Department:
Environment & Nature Conservation
NORTHERN CAPE PROVINCE
REPUBLIC OF SOUTH AFRICA

Reference : DE Ref.: 14/12/16/3/3/1/2012
Tshupelo : 14/12/16/3/3/1/2013
Isalathiso :
Verwysing :

RE: BASIC ASSESSMENT FOR VELD PV NORTH AND SOUTH ENERGY FACILITIES ON FAMR 53 HARAMOEP, KHAI MA LOCAL MUNICIPALITY, NAMAKWA DISTRICT MUNICIPALITY

Figure 1: Farm Haramoep in relation to ecological Corridors: Gariep Centre of Endemism and Important Bird Area

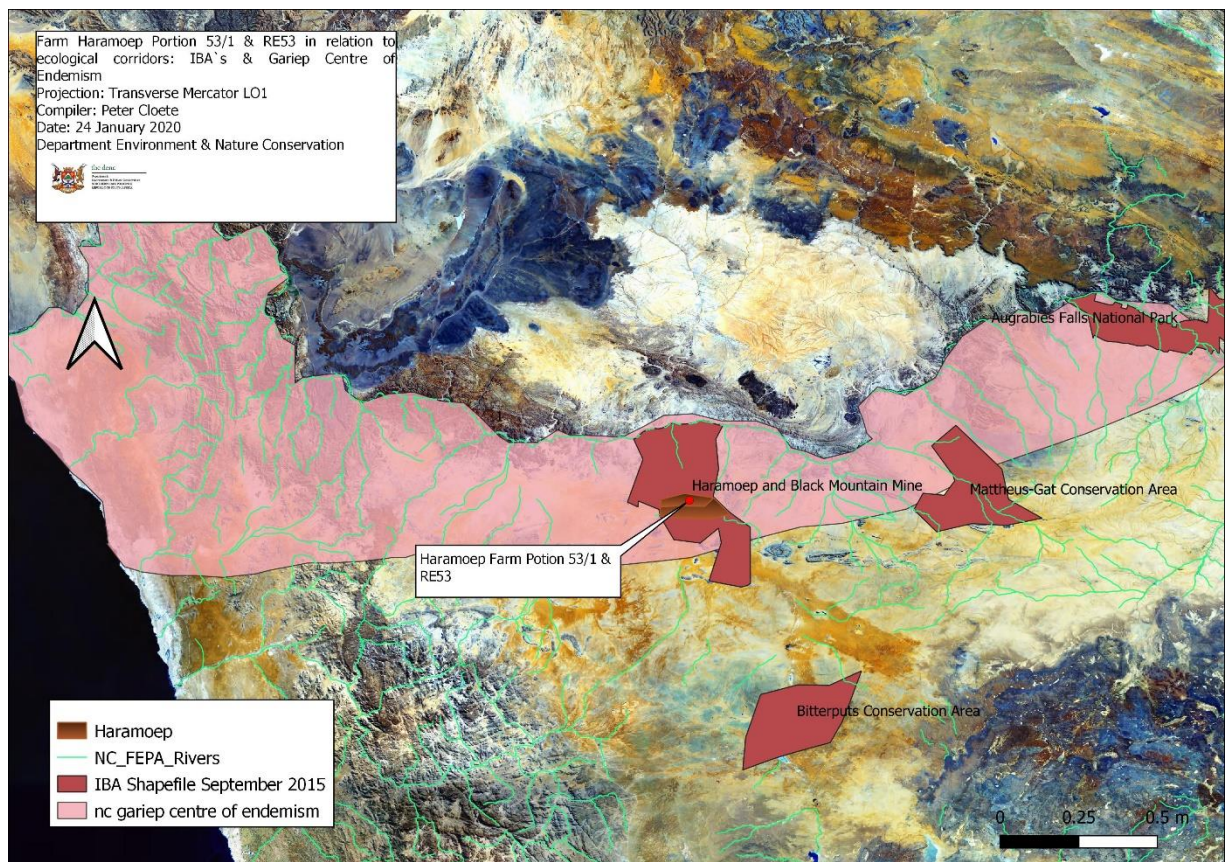
The study area also falls within important ecological corridors such as the Gariep Centre of Endemism, and the Aggeney's Haramoep Important Bird Area (Figure 1). The farm Haramoep also falls within the Northern Cape Protected Area Expansion Focus Areas (Figure 2).

Figure 3: Solar and mine developments within the surrounding area

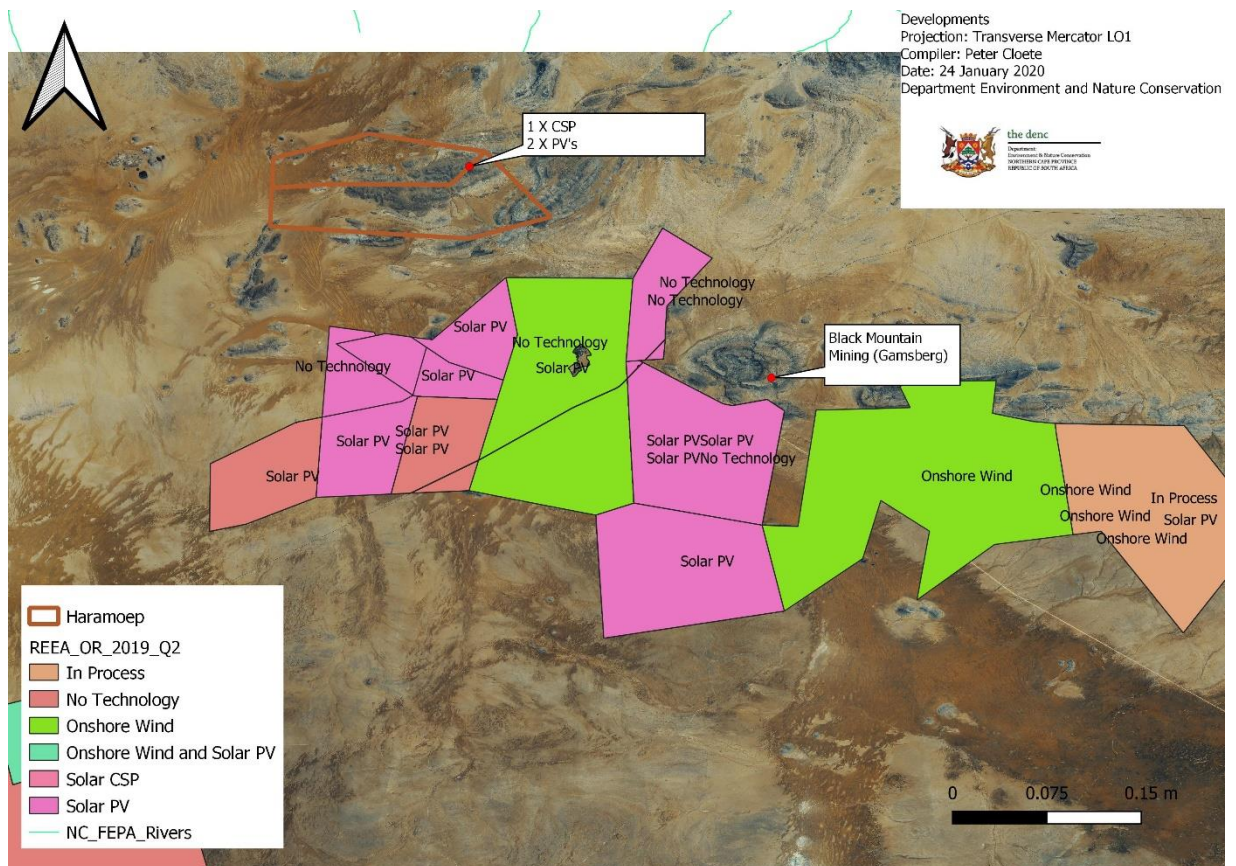
The cumulative impacts of the other developments (e.g. mining as well as other solar developments) in the surrounding area were not considered in the study. Not to say that the applicants needs to take responsibility for other developers but to assess the impacts of the proposed development on ecosystem function and specific vegetation units and/or protected species status on a local and regional scale is required.
